**SAFETY EVALUATION FOR PROPOSED  
TECHNICAL SPECIFICATION CHANGES TO  
ASME SECTION XI SURVEILLANCE TESTING**

(JPTS-93-003)

**JAMES A. FITZPATRICK NUCLEAR POWER PLANT**

Docket No. 50-333

B. Containment Cooling Mode (of the RH-R System)

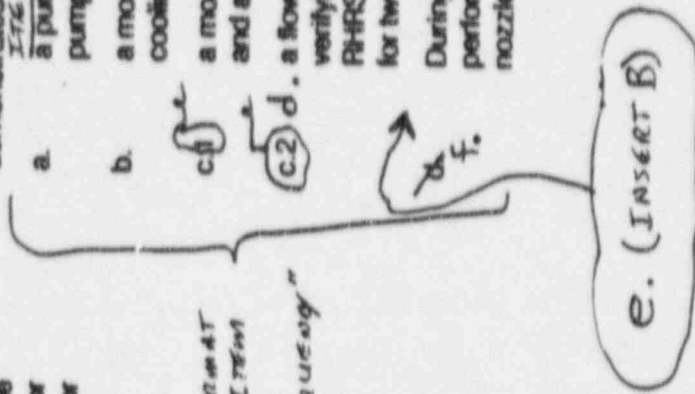
REMOVE CHANGE BAR

- 1. Subsystems of the containment cooling mode shall be demonstrated operable by performing:
  - a. a pump operability and flow rate test on the RH-R pumps per Surveillance Requirement 4.5.A.3.
  - b. a monthly operability test of the RH-R containment cooling mode motor operated valves.
  - c. a monthly operability test on the RH-RSW pumps and associated motor operated valves.
  - d. a flow rate test at least once every 3 months and verifying a flow rate of 4000 gpm for each RH-RSW pump and a total flow rate of 8000 gpm for two RH-RSW pumps operating in parallel.
